14 February 2025

ADDENDUM NO. 3

RE: Chisholm Creek Utility Authority  
Wastewater Treatment Facility Improvements  
WCI File: 20-600-514-00

SHEET NO:  
**E-471**

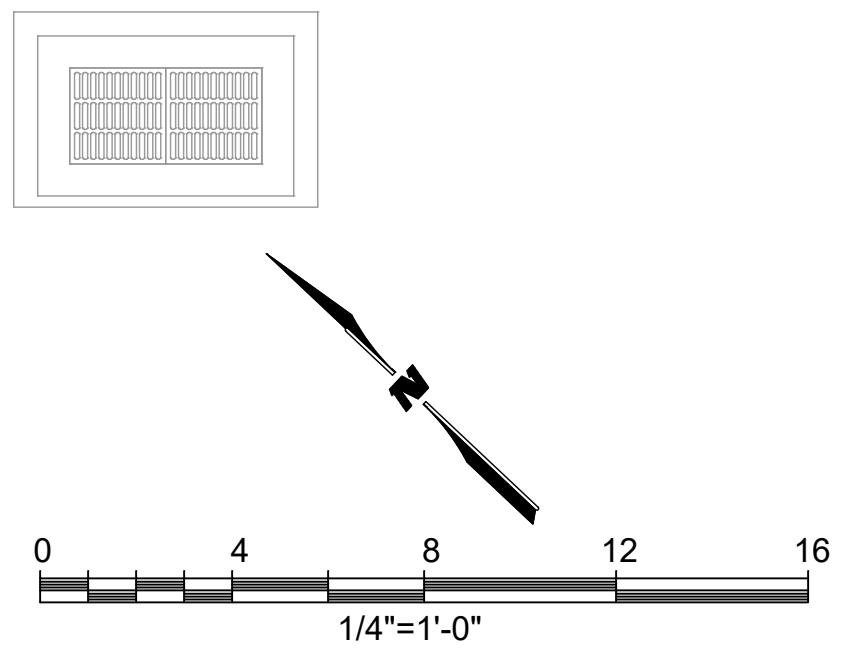
16. Sheet No. E-451  
ADDITION of North arrow.  
ADDITION of conduits C106 and C107.  
ADDITION of Keyed Note 7.
17. Sheet No. E-471  
ADDITION of conduit C108.  
ADDITION of Keyed Note 5.

SHEET NO: E-621

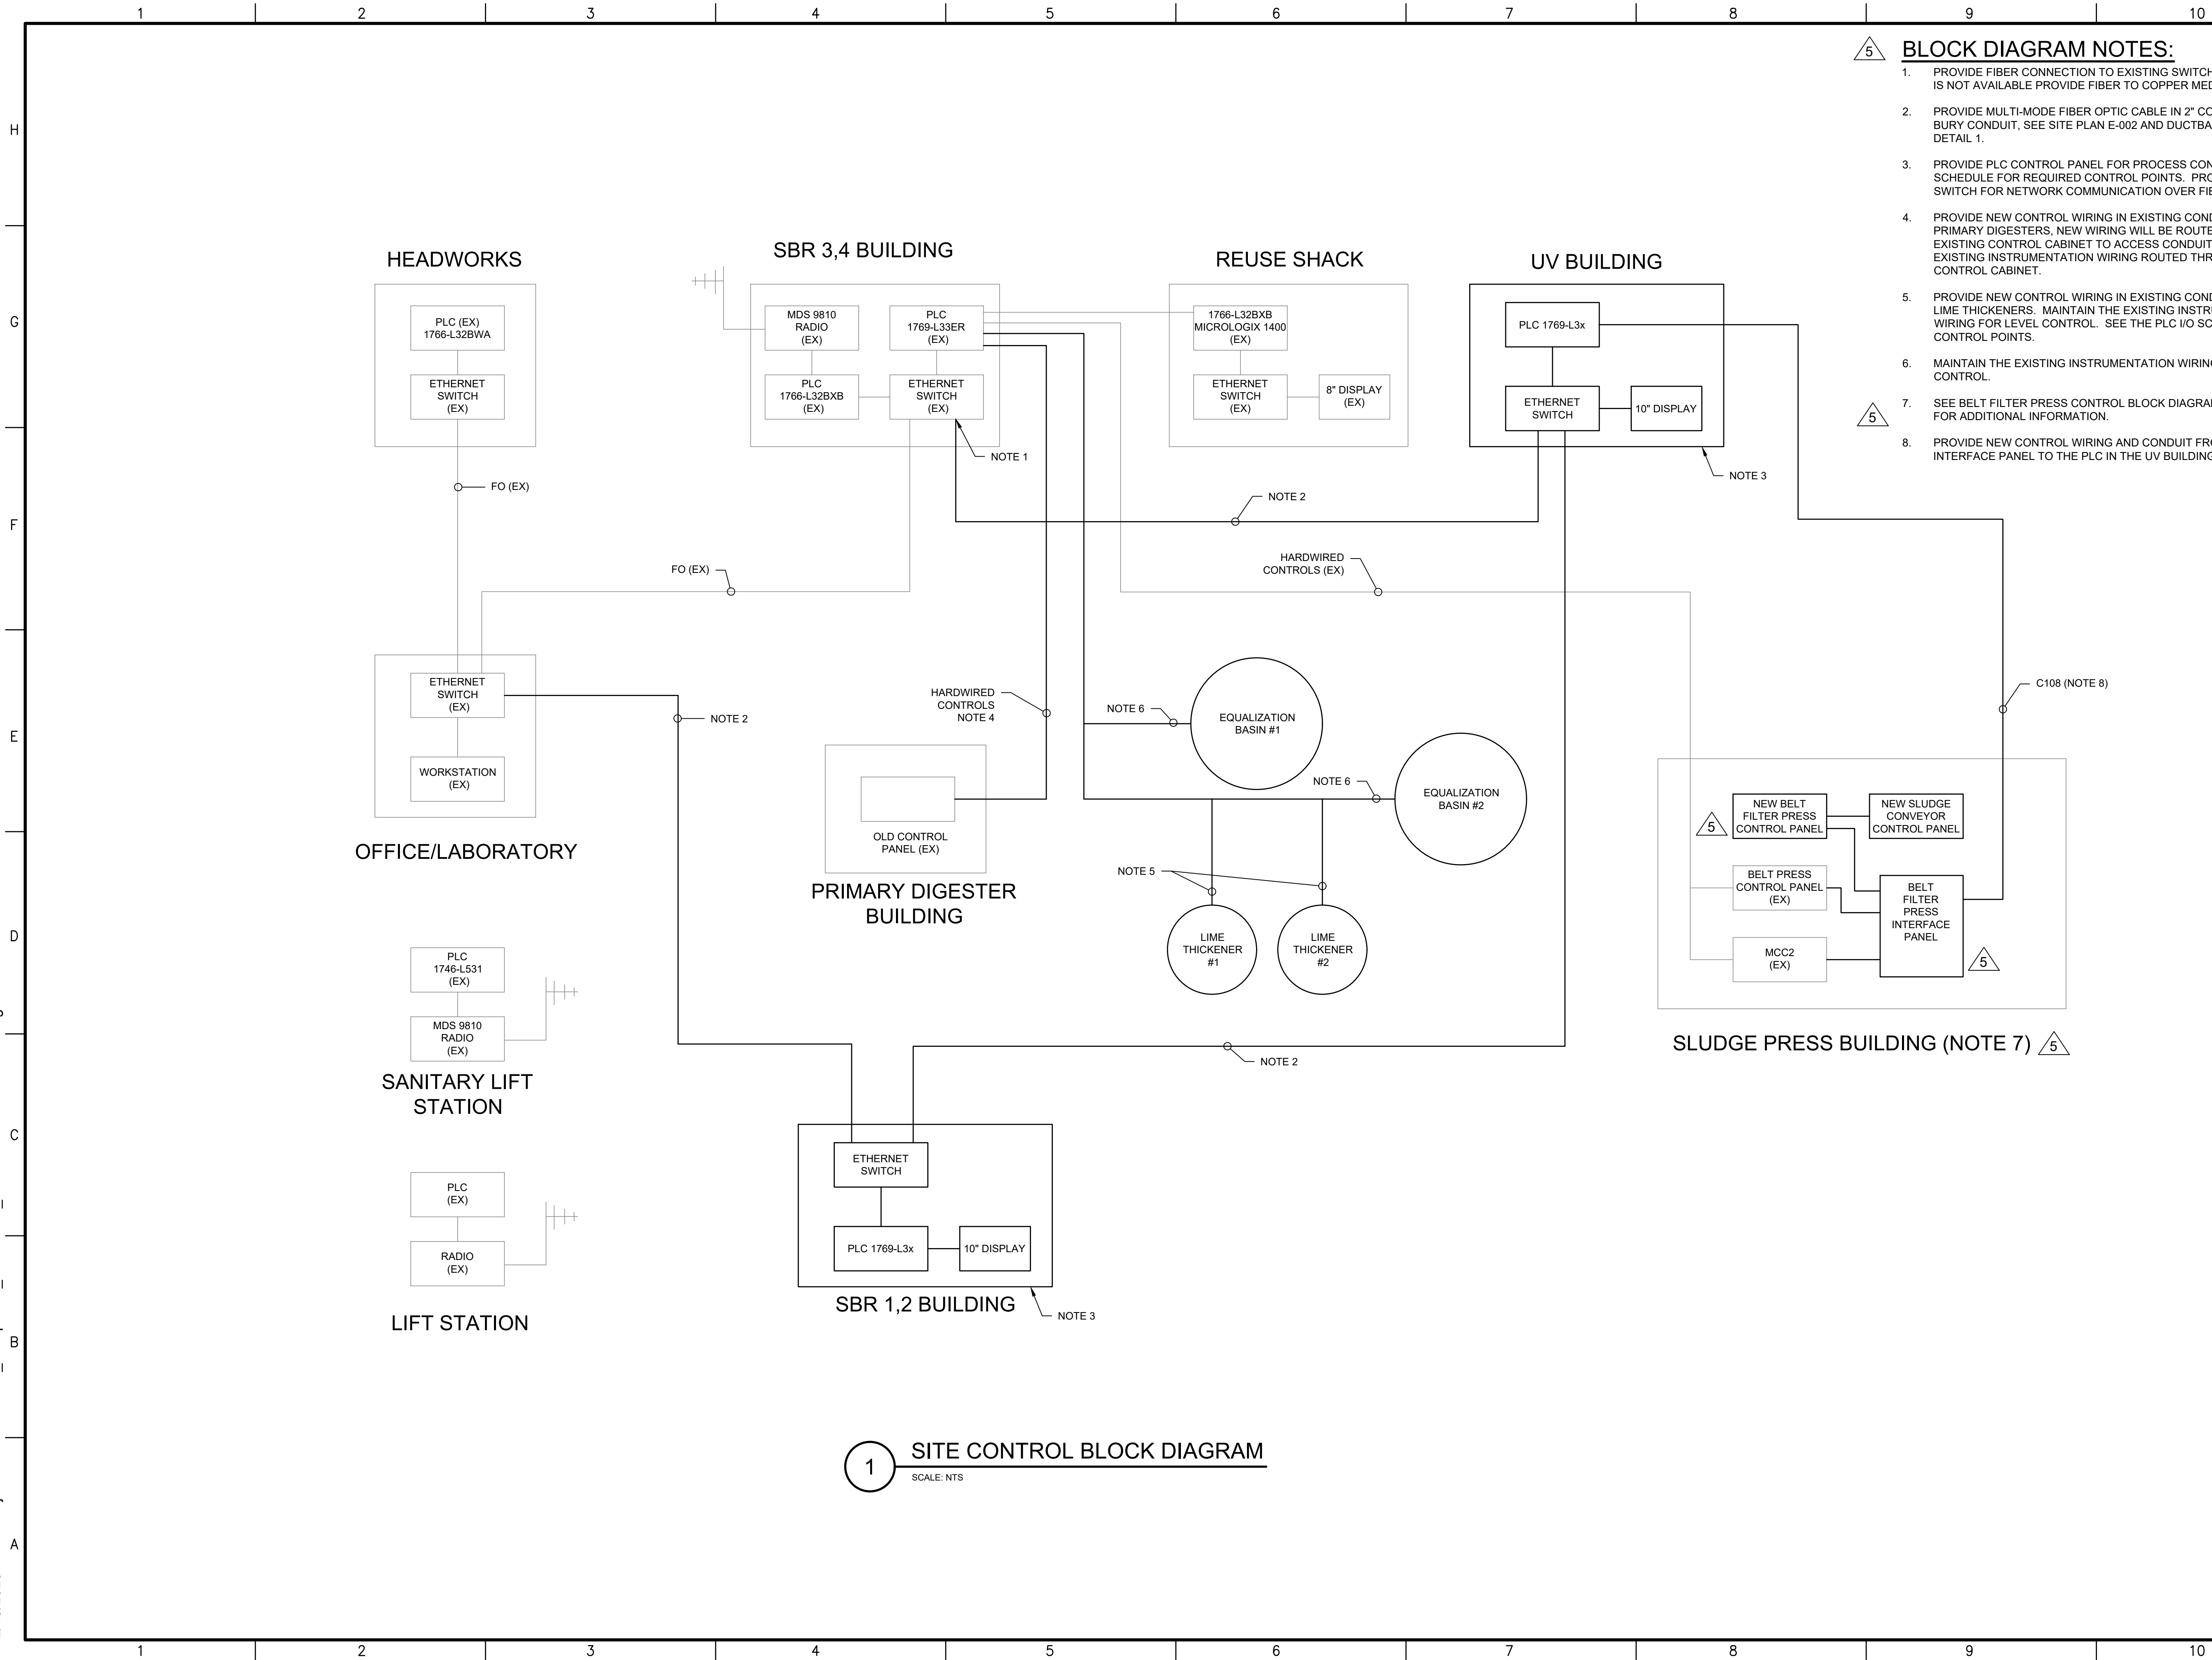
20. Sheet No. E-621  
ADDITION of Headworks Building PLC Input I/O schedule.
21. Sheet No. E-701  
REMOVED connection between the New Belt Filter Press Control Panel and existing hardwired controls.  
ADDITION of the Belt Filter Press Interface Panel and associated control signals.  
REVISED notes heading to say Block Diagram Notes instead of One-Line Notes.  
ADDITION of Block Diagram Note 7 and 8.
